Summary of Items Discussed in 5/2012 APSEC Discussion Forum on 26 October 2012

Figure 16A – Handrails of Staircase

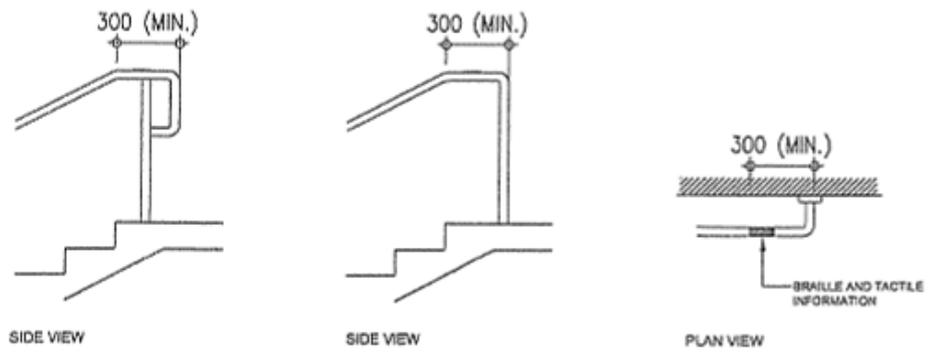
9.	<p><u>Location of Braille at Staircase Handrail</u></p> <p>As per attached diagram, please advise whether the direction of the braille should be pointing downwards or upwards at the top of a flight of stairs.</p>	<p>The Appendix C added in the proposed revised PNAP APP-41 would clarify the location of the “UP” and “DOWN” Braille signs on handrails and this PNAP would be issued shortly.</p> <p>(Post-meeting Note : PNAP APP-42 was issued in November 2012.)</p>

Refer to item 10

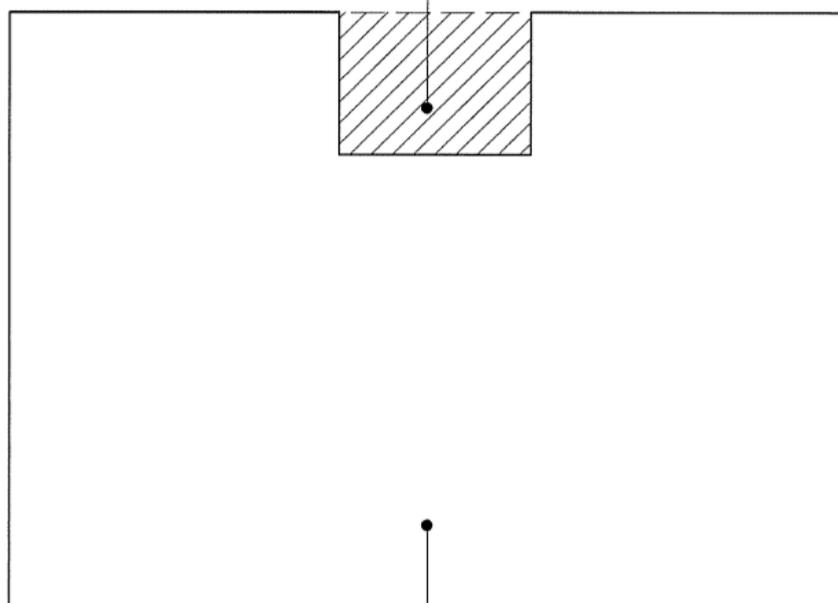
<p>10.</p>	<p><u>Area of Recess at Entrance from Building Frontage Accountable for GFA</u></p> <p>As per attached diagram showing the outline of a house, the area hatched is required to be accountable for GFA even though no exemption from building regulation is involved. As understood from previous discussion with BD that BD may take into consideration the likelihood of abuse while granting exemption, which is fair enough. However, in this case where no exemption is involved, BD is requested to advise the ground of disapproval so that we can explain to the developer accordingly.</p>	<p>BD responded that genuine recessed and uncovered area of reasonable size in a house might not be required to be accountable for GFA calculation.</p>
<p>11.</p>	<p><u>Location of Void in a House</u></p> <p>BD is requested to advise whether it is a rule that the void above living/dining room must be easily visible from the outside before the exemption can be granted.</p>	<p>BD responded that according to PNAP APP-2, a void above living / dining room in a house should be easily visible from outside. Voids facing the sea would be acceptable as long as they could be visible from outside, such as a beach and walking trails.</p>

Refer to item 12

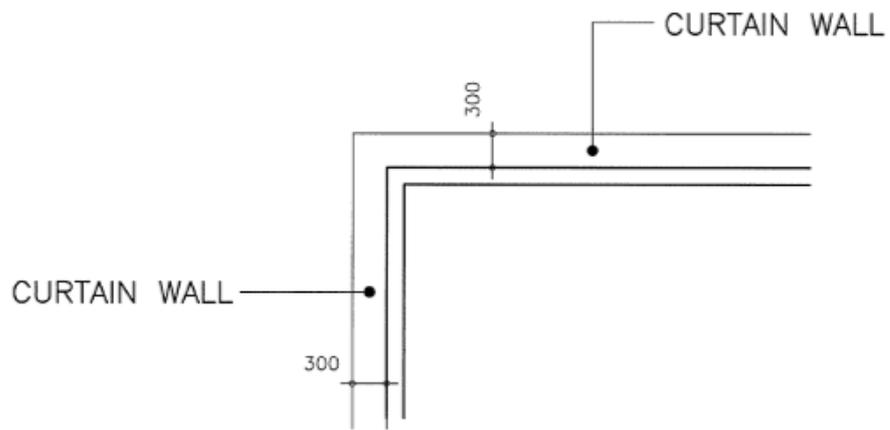
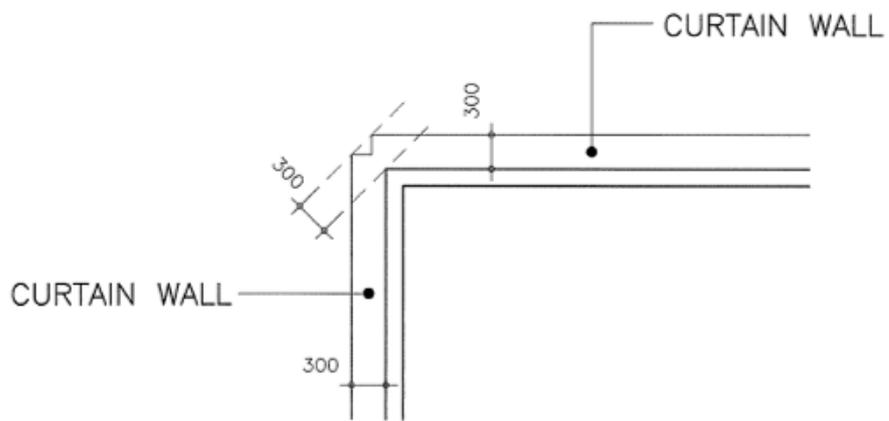
<p>12.</p>	<p><u>Exemption of Curtain Wall at Corner of Building</u></p> <p>As per attached drawing, if the curtain wall to 2 sides of the building is already to the maximum allowable depth, would BD accept the projection as shown in case 1 and if not is it acceptable as in case 2 that the curtain wall is within the limit measured from the corner of the building.</p>	<p>For the purpose of PNAP APP-2, BD accepted that part of a curtain wall system wrapping around the corner of a building in accordance with Case 1 to be disregarded from GFA and SC calculations.</p>
